## ADDENDUM No. 1

PROJECT: University Medical Center  
CV/CICU Renovation &  
NICU Renovation  
602 Indiana Avenue  
Lubbock, Texas 79415

DATE: 05/12/2025  
PROJECT NO.: 22307 & 22419

1/M2 PARTIAL SIXTH FLOOR PLAN - SOUTH - MECHANICAL  
SCALE: 1/8" = 1'-0"

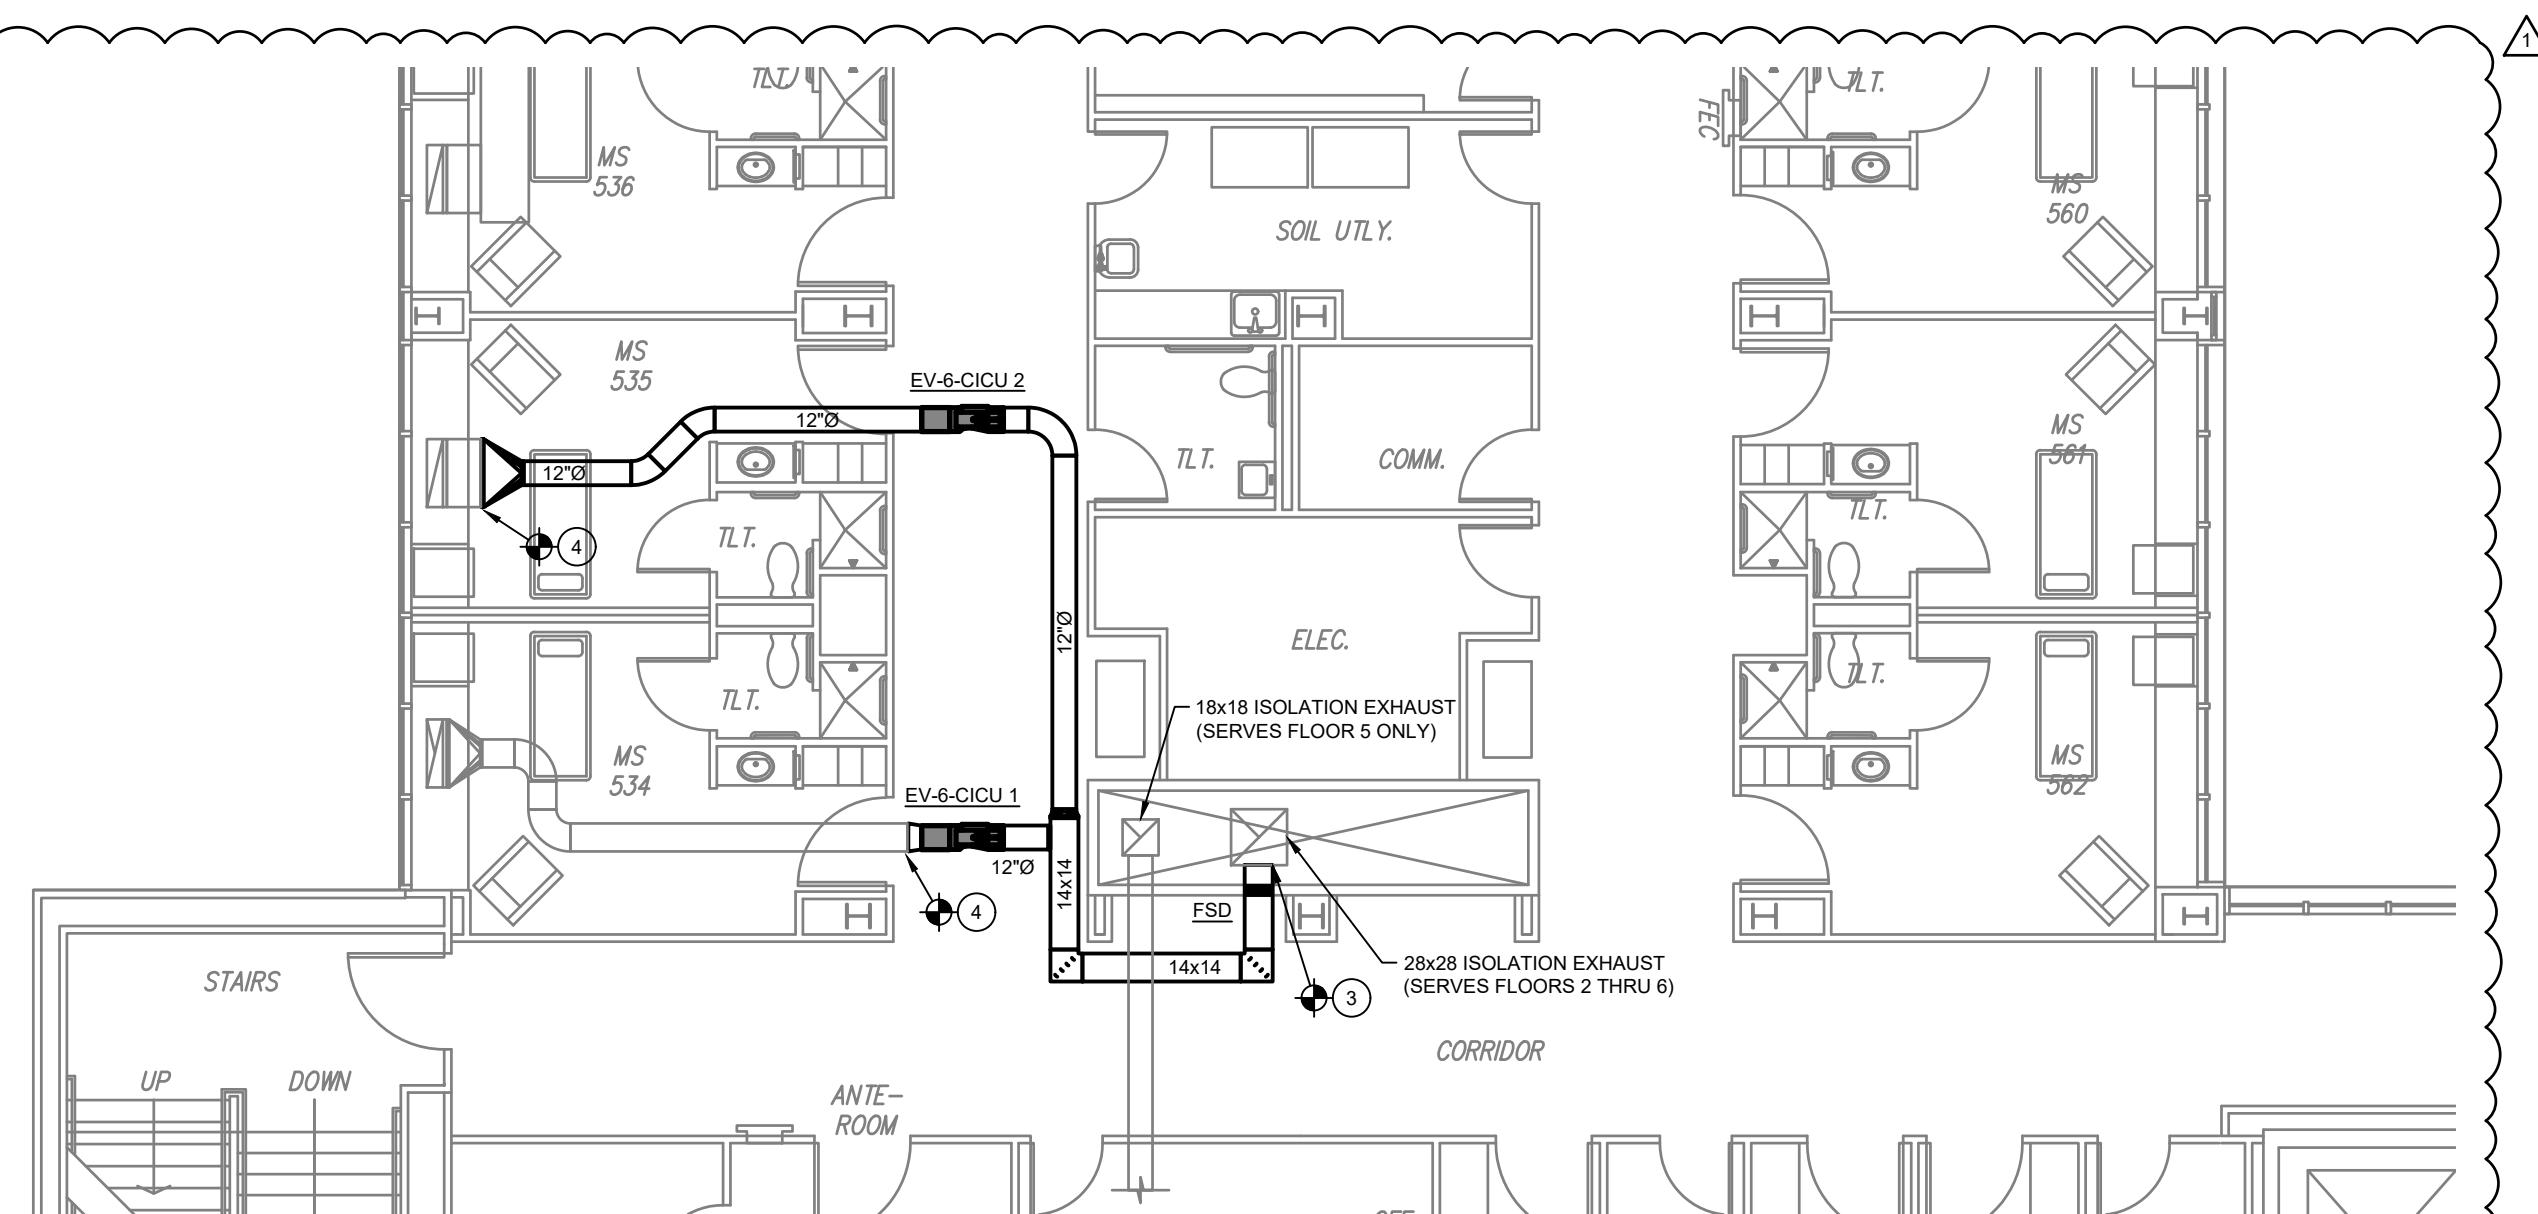
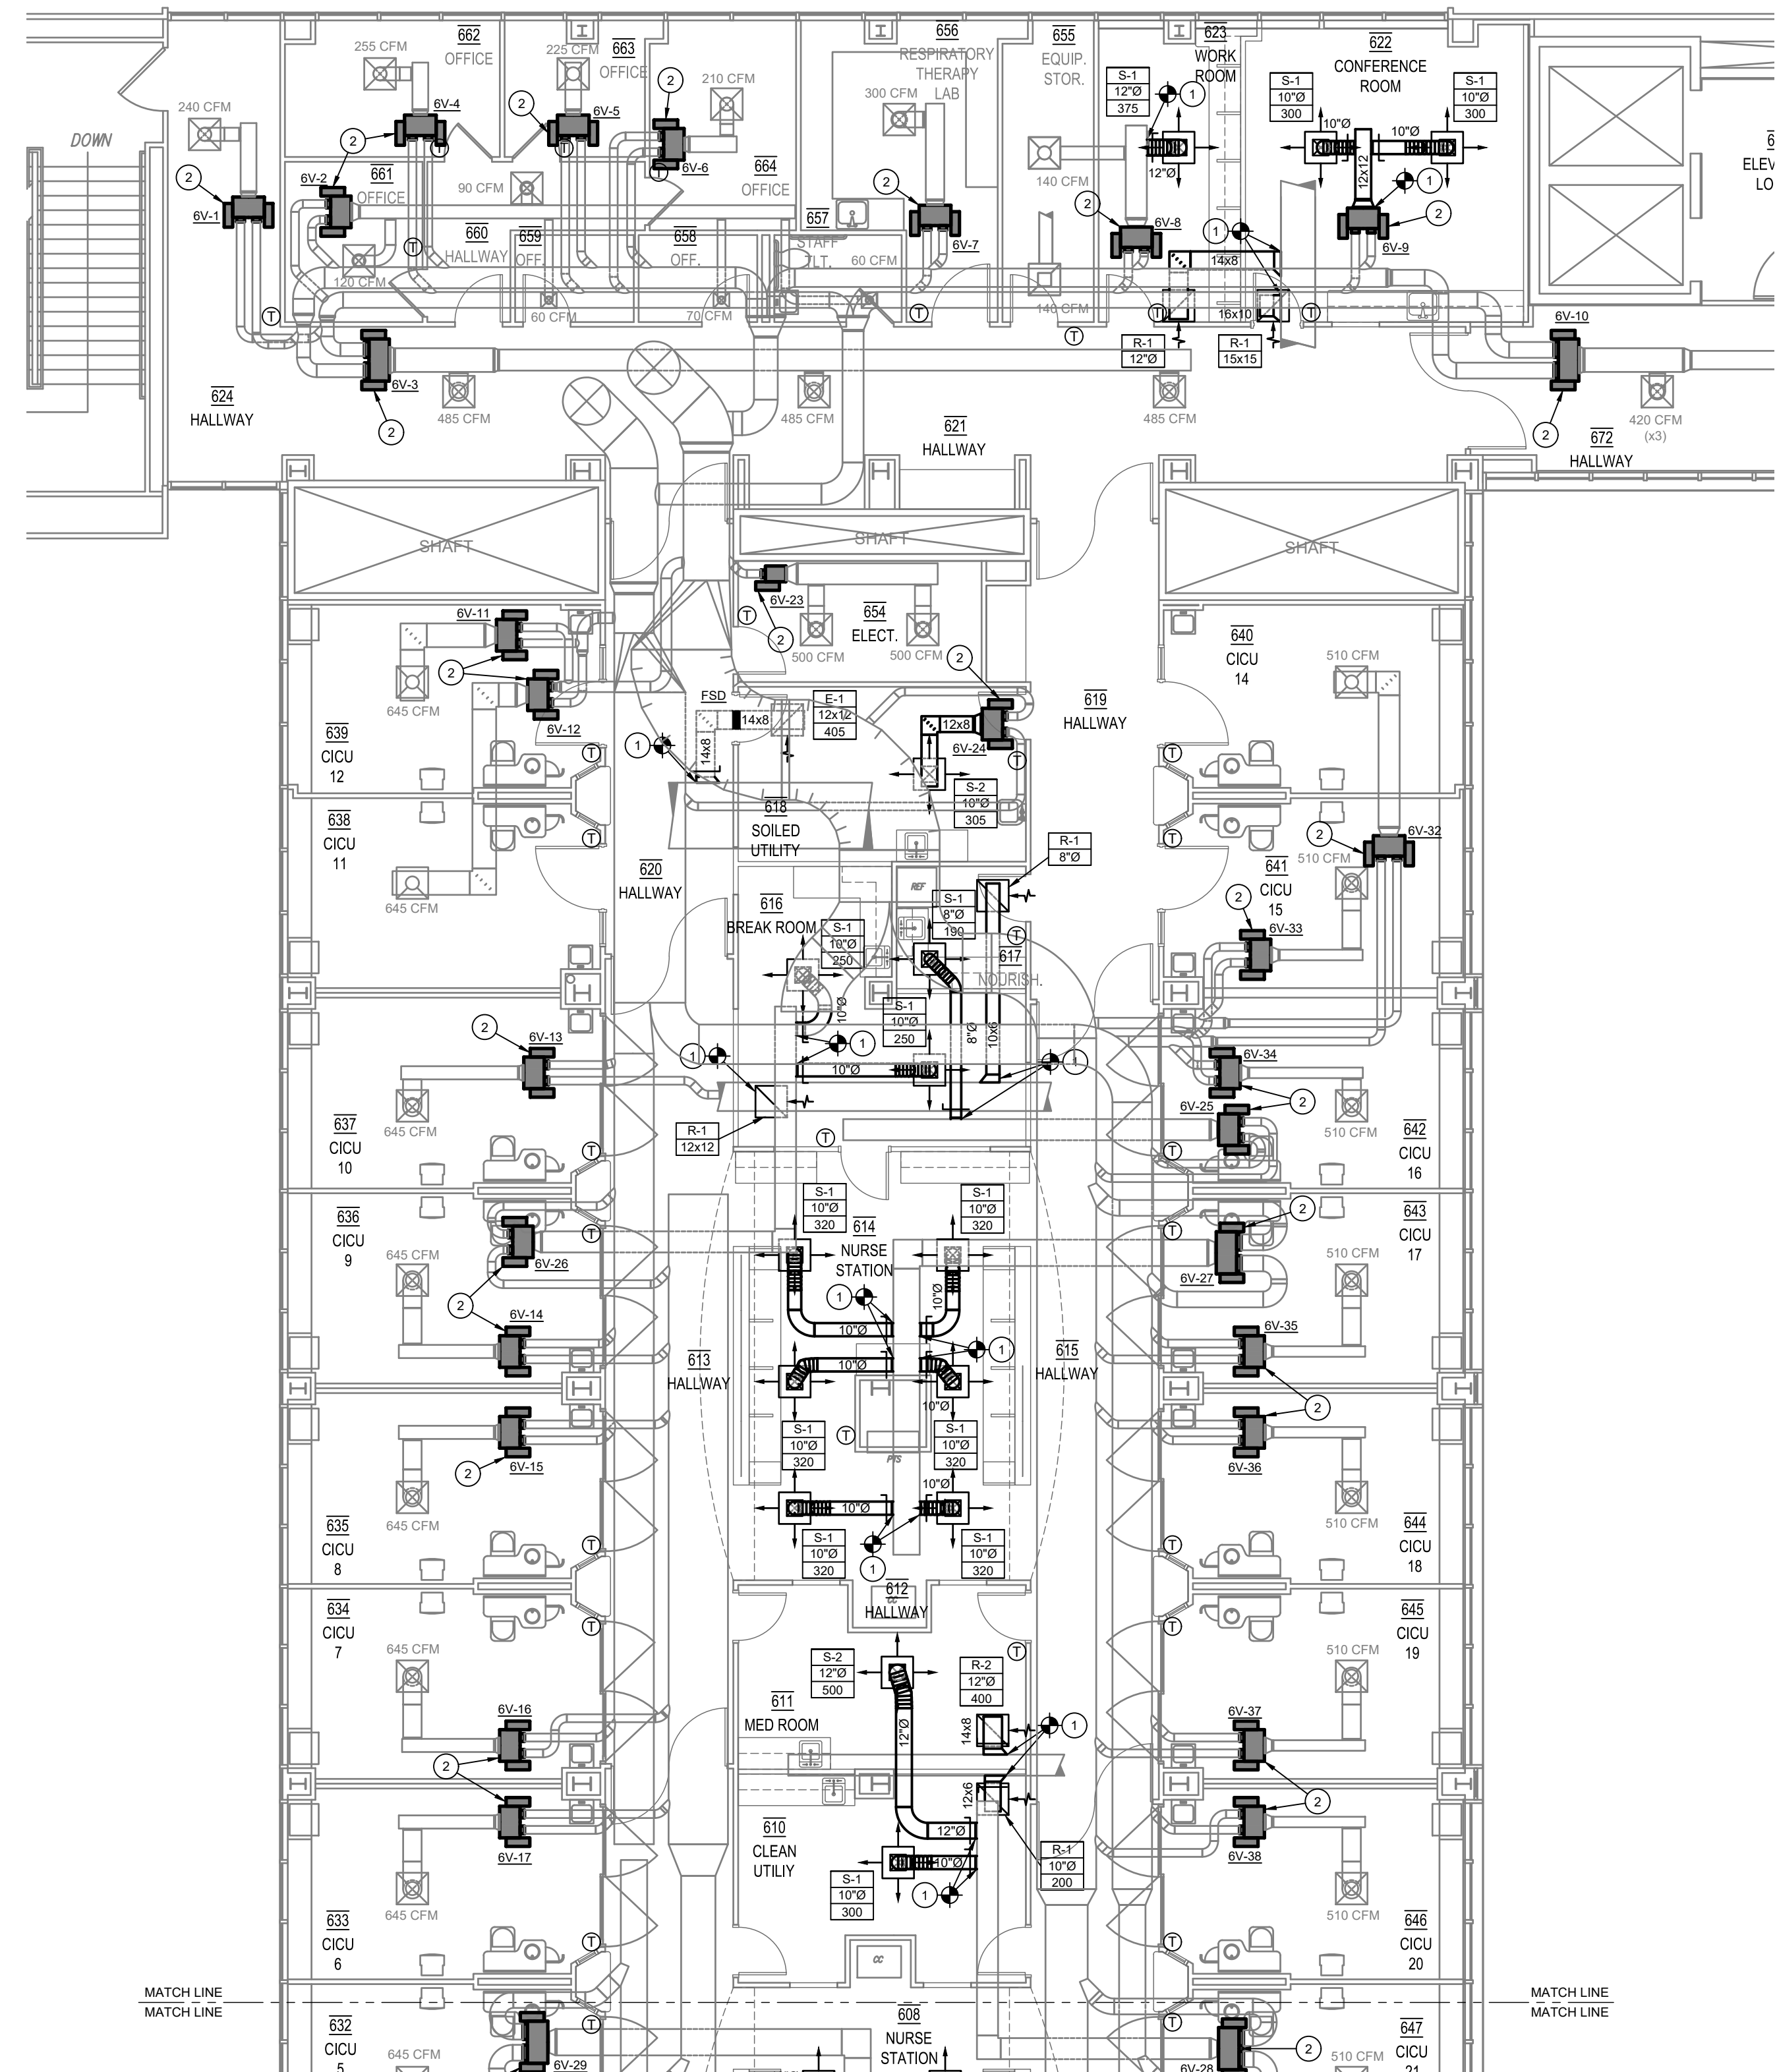
### Item 2. Drawing Sheet M2:

- a. Provide supply air valves, additional ductwork, and pressure sensors for CICU 1 and CICU 2 Rooms in order to convert these rooms into Isolation Rooms.
- b. Provide additional ductwork and exhaust air valves on Fifth Floor serving low exhaust for CICU 1 and CICU 2 Rooms in order to convert these rooms into Isolation Rooms.

- c. Provide new VAV Box and ceiling diffusers and grilles serving elevator lobby. The VAV Box replacement shall be under Bid Alternate #3. The replacement of the ceiling diffusers and grilles shall be under Bid Alternate #4.

2.	UNDER ALTERNATE BID #3: PROVIDE NEW VAV BOX LOCATED IN SAME LOCATION AS REMOVED VAV BOX. MODIFY INLET AND OUTLET DUCTWORK AND PROVIDE TRANSITIONS AS REQUIRED TO MATCH UNIT CONNECTION SIZES. PROVIDE NEW DIGITAL THERMOSTAT IN PLACE OF EXISTING PNEUMATIC THERMOSTAT. BALANCE NEW VAV BOX AND ALL CONNECT DIFFUSERS TO AIRFLOWS LISTED ON PLANS.

5.	CONNECT NEW COLD AND HOT HIGH PRESSURE DUCTS TO EXISTING DUCTS AND ROUTE TO NEW SUPPLY AIR VALVE. PROVIDE MOTORIZED DAMPERS IN EACH DUCT AND CONNECT BOTH DUCTS INTO WYE FITTING TO INLET ON SUPPLY AIR VALVE. PROVIDE INLET AND OUTLET TRANSITIONS AS REQUIRED.

6.	NEW ROOM DIFFERENTIAL PRESSURE SENSOR. READOUT SCREEN SHALL BE ON HALLWAY SIDE OF WALL.
7.	EXISTING LOW RETURN/ EXHAUST GRILLE TO BE UTILIZED FOR NEW ISOLATION EXHAUST SYSTEM. CLEAN EXISTING GRILLE AND INSIDE OF EXISTING DUCTWORK AS MUCH AS POSSIBLE. EXHAUST AIR VALVE SERVING THIS GRILLE IS LOCATED ON FLOOR BELOW.

8.	UNDER ALTERNATE BID #4: REPLACE CEILING DIFFUSER/ GRILLE IN ELEVATOR LOBBY
